SYNGENE INTERNATIONAL LTD, VELANKANI TECH PARK, ACCESSIBILITY AUDIT REPORT

PREPARED BY SVADHIN SOLUTIONS

GROUND FLOOR, SYNGENE INTERNATIONAL, VTPL – ACCESSIBILITY OVERVIEW

MAIN STAIRCASES

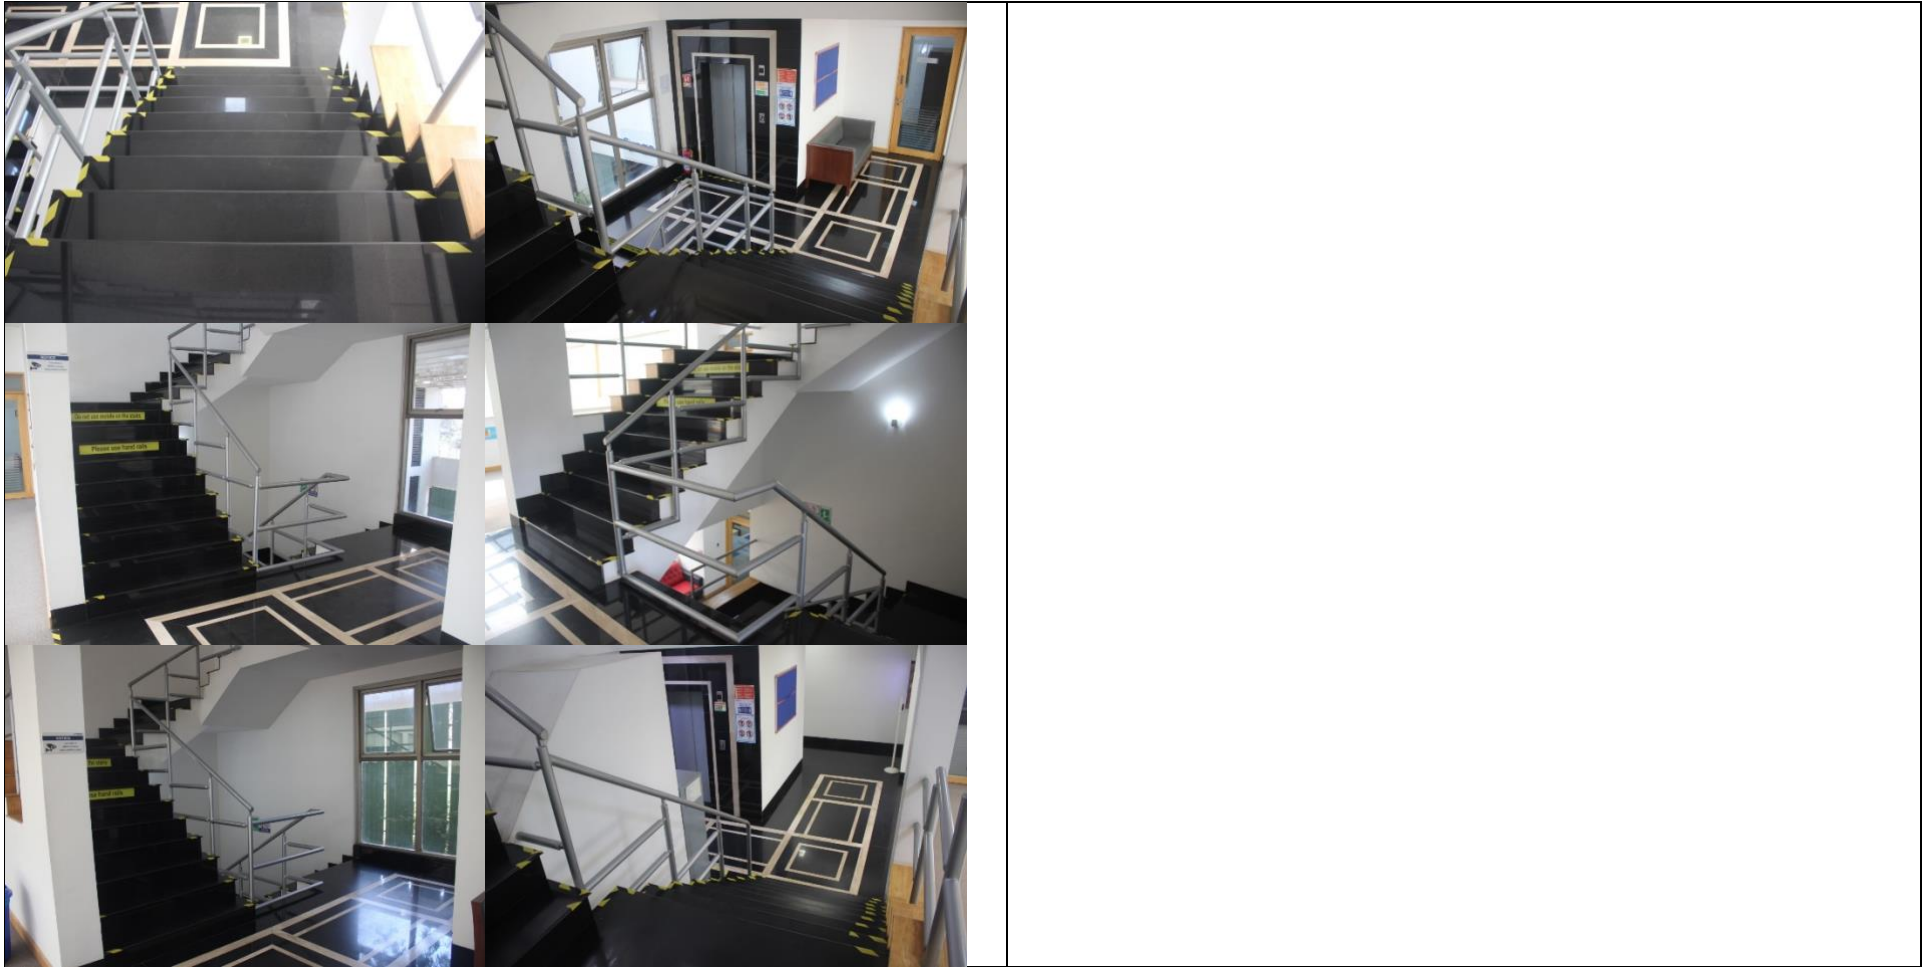
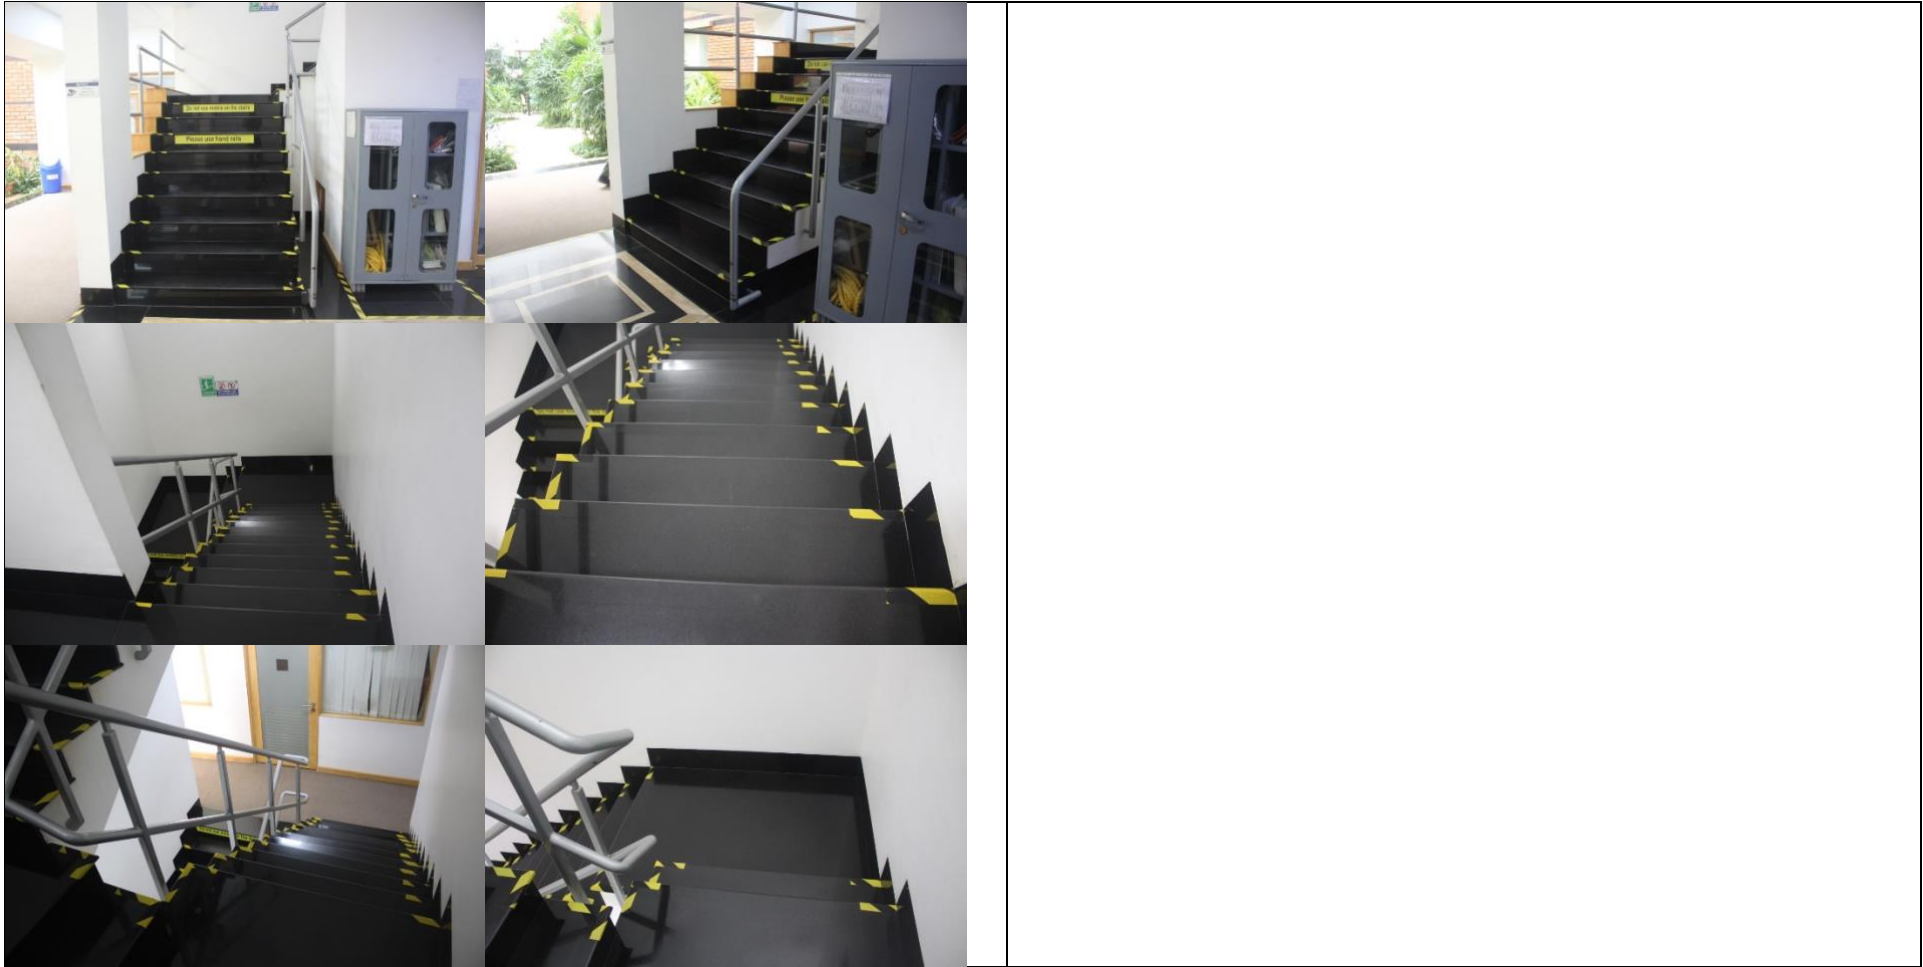
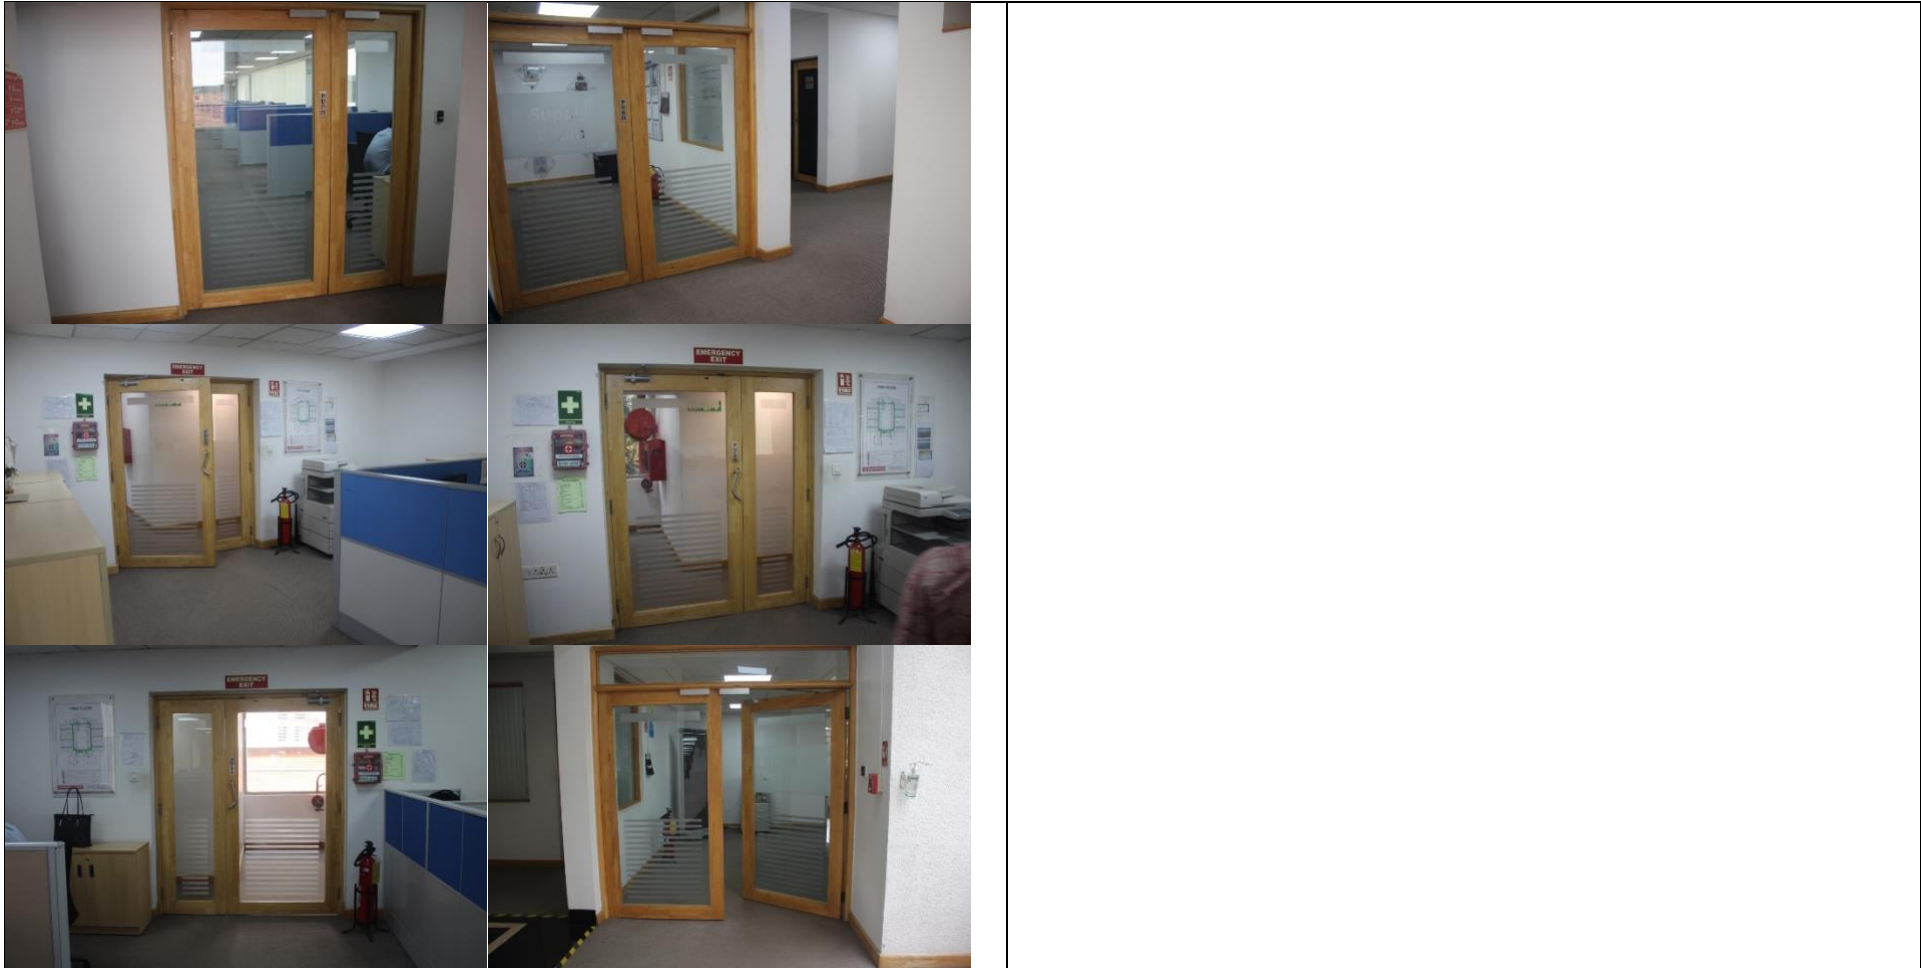
- Both the main staircases (front and back) have no floor identification signage on the staircase floor landings with provisions for braille and tactile making navigation challenging, non-compliant and inaccessible for PwDs
- Both the main staircases (front and back) have emergency instructional/directional signage placed at non-compliant and inaccessible heights without provisions for braille and tactile making them non-compliant and inaccessible for people with visual impairment and certain other PwDs
- The central running handrails of both the staircases (front and back) do not have handrail extensions at the top and bottom landings and the staircases are missing continuously running wall side handrails with extensions into the landings making both these staircases non-compliant and hard to use for certain PwDs

- The handrails are not completely accessible for people with visual impairment as they are lacking in braille markings for identification of the floor on each landing

- The front staircase handrails on the left side below the beam for the flight that is coming into the landing areas have inaccessible clearance from handrail to the beam making this part of the handrails possibly unsafe for certain PwDs and the head clearance non-compliant

- All the steps in both the staircases have non-compliant colour markings and there are no antiskid provisions for all the step treads making both the staircases non-compliant and unsafe for PwDs

- While, the back staircase width is inaccessible, the front staircase width is non-compliant when the wall-side handrails will be added and both the staircases have non-compliant staircase landing widths making them both non-compliant and inaccessible for PwDs

- Access to the front staircase from the third floor office entry has steps to access the staircase which don't have handrails and are missing anti-skid provisions for the step treads making them non-compliant

- The back staircase entry from the floor landings have small level differences because of the improperly flushed carpeted floors at certain points which may be unsafe for certain PwDs

- There is no identification signage marking the usage of the main staircase for everyday purposes

FLOOR ENTRANCES

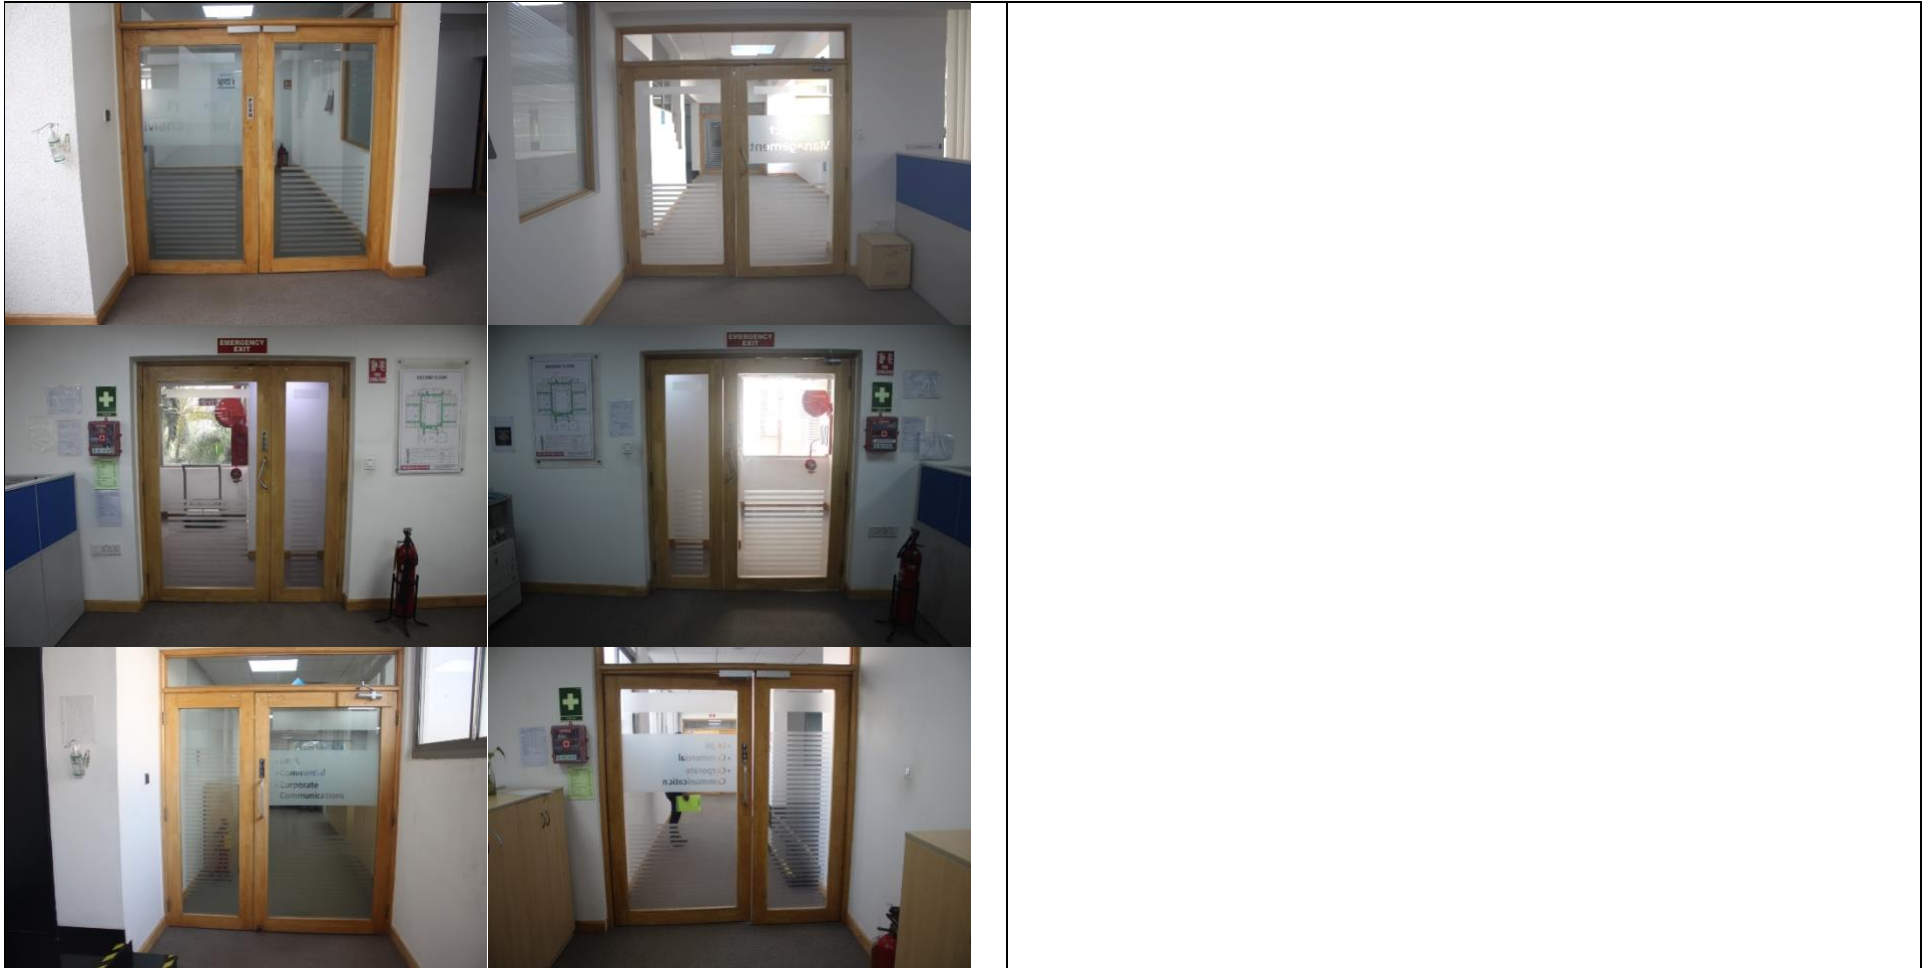
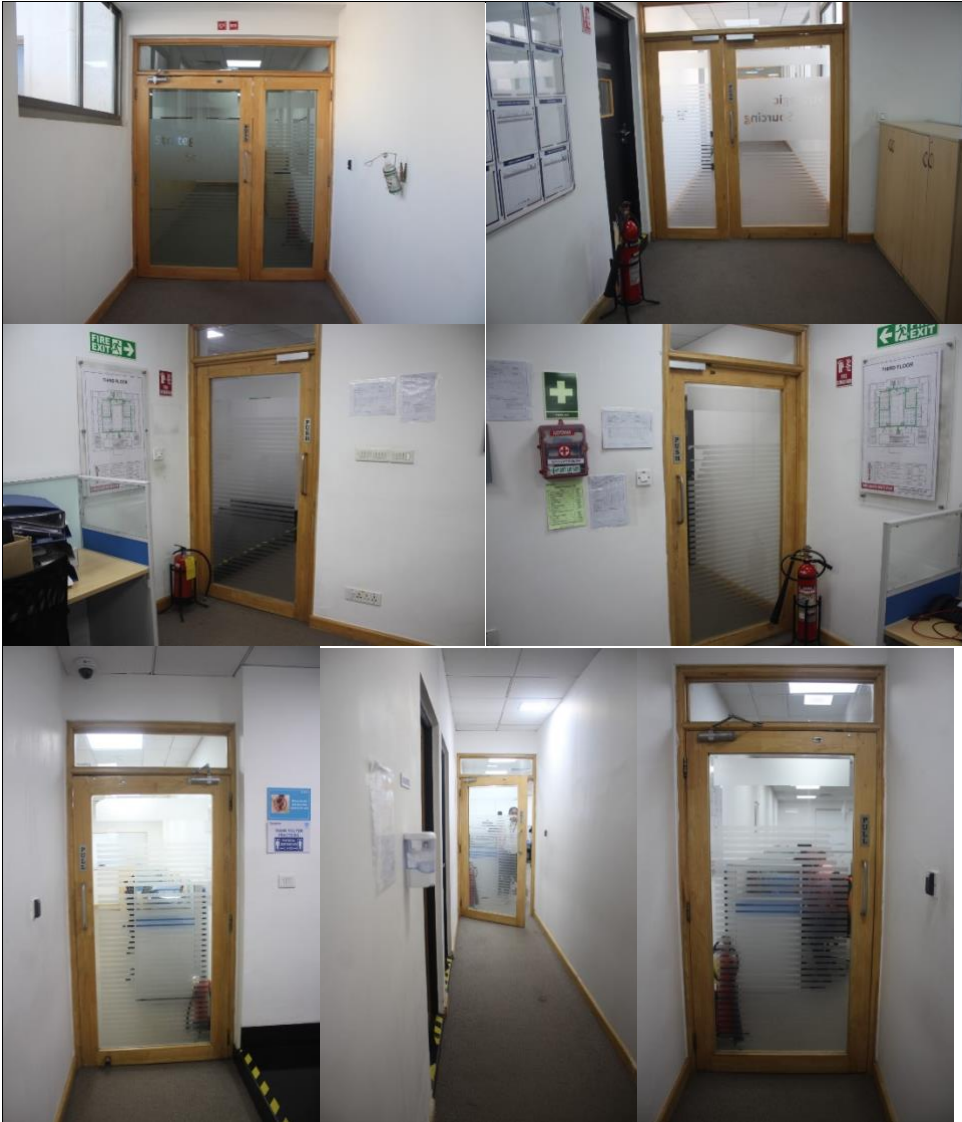
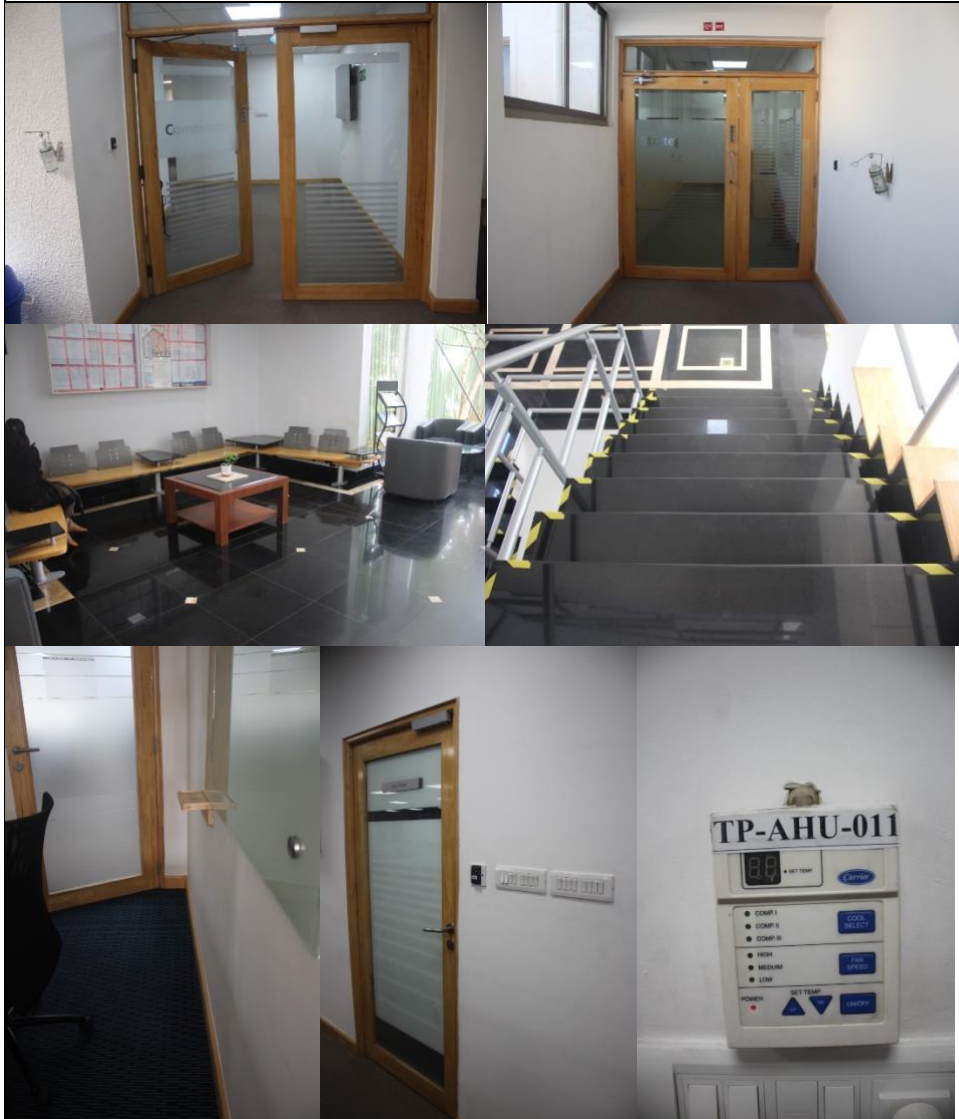
- None of the floor entrance doors have an accessible identification signage with provisions for braille and tactile with strong colour contrast making them inaccessible and non-compliant
- All the floor entry doors have high door tension except for the floor entry door on third floor near the pantry and handles placed at inaccessible heights making them non-compliant and inaccessible for PwDs
- Both the third floor entry doors towards the toilet blocks have inaccessible pull side door clearances making them non-compliant and inaccessible for PwDs

- The access card readers and the PTRs placed next to all the floor entry doors are at non-compliant heights without any braille and tactile identification labels for people with visual impairment making them non-compliant

- All the fire alarms placed at the floor entry doors are at non-compliant heights and do not have provisions for braille and tactile making them non-compliant and inaccessible for certain PwDs

- The wall mounted hand sanitizers near all the floor entry doors are placed at inaccessible heights and act as projections making them inaccessible and unsafe for different PwDs

- All the first aid kits placed near the second and third floor entry doors are placed at inaccessible heights and do not have provisions for braille and tactile signage making them inaccessible for PwDs

- The fire extinguishers placed near the third floor entry doors towards the toilet blocks reduce the movement path at the door way
- None of the floor entry doors have kick plates as required by compliance

- All the floor entry doors have no accessible directional signage with provisions for braille and tactile making it difficult for PwDs to navigate from hereon
